SERVICE BULLETIN

ENGINE - MAIN GEARBOX ASSEMBLY - INCORPORATE A TWO-PIECE OIL PRESSURE TUBE SUPPORT BRACKET - CATEGORY CODE 7 - MOD.ENG-72-0055

V2500-ENG-72-0055

Oil pressure tube support brackets
Fig.1

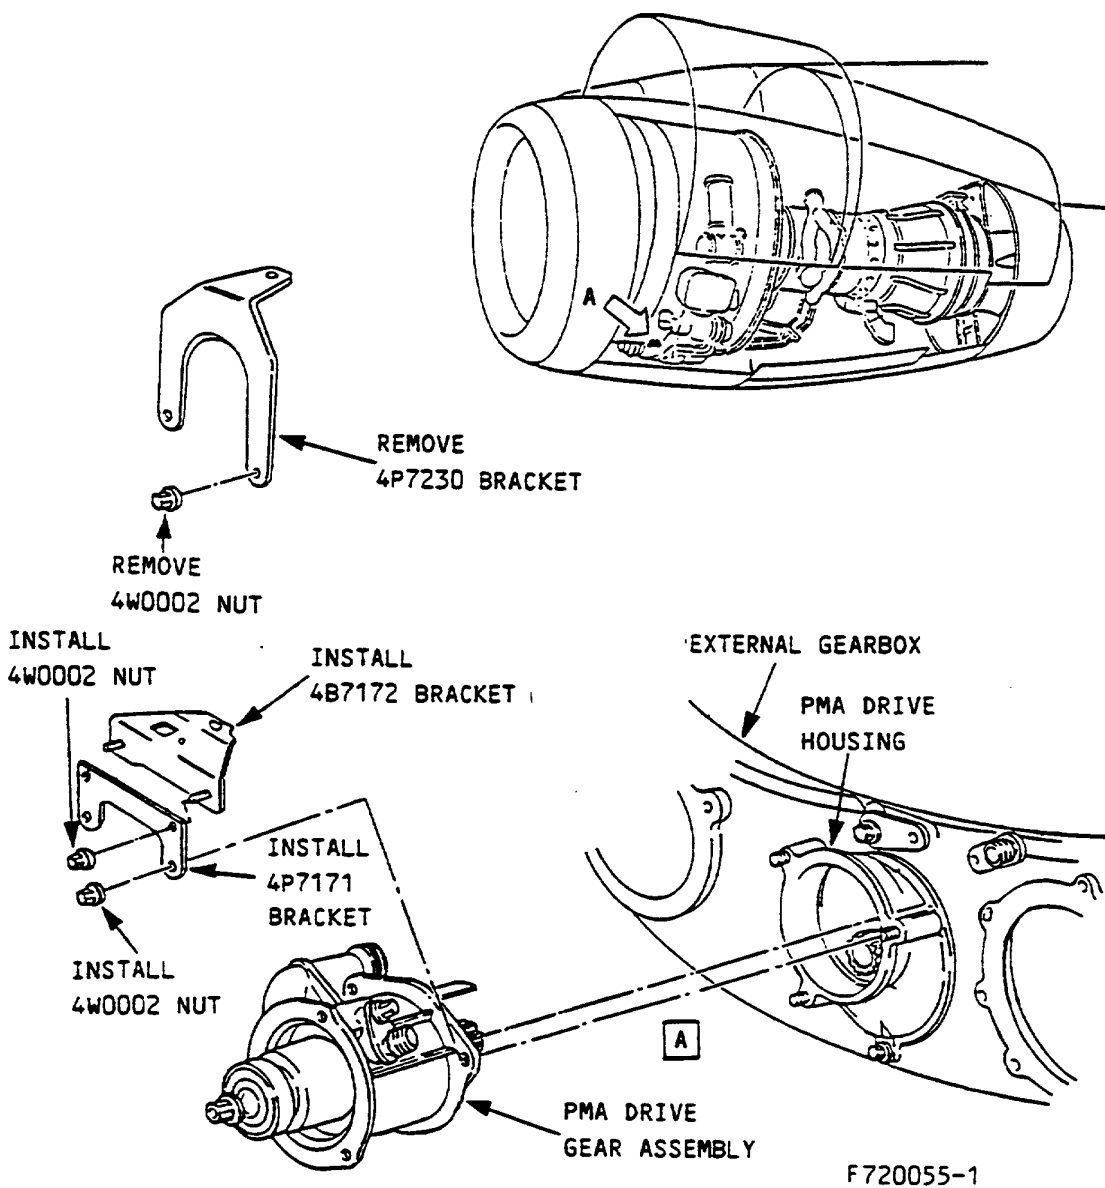
The removal of the PMA Drive Gear Assembly is impeded by the support bracket. To eliminate this condition, the bracket has been divided in two parts.

To facilitate the removal and installation of the PMA drive gear assembly.

4P7171 (72-60-10)	1	14.90	Bracket	4P7230 (01-630)	(A)(B)(S1)
4B7172 (72-60-10)	1	47.40	Bracket, assembly	- (01-632)	(A)(S1)
4W0002 (72-60-10)	2	5.66	Nut	- (01-637)	(A)(B)(C)
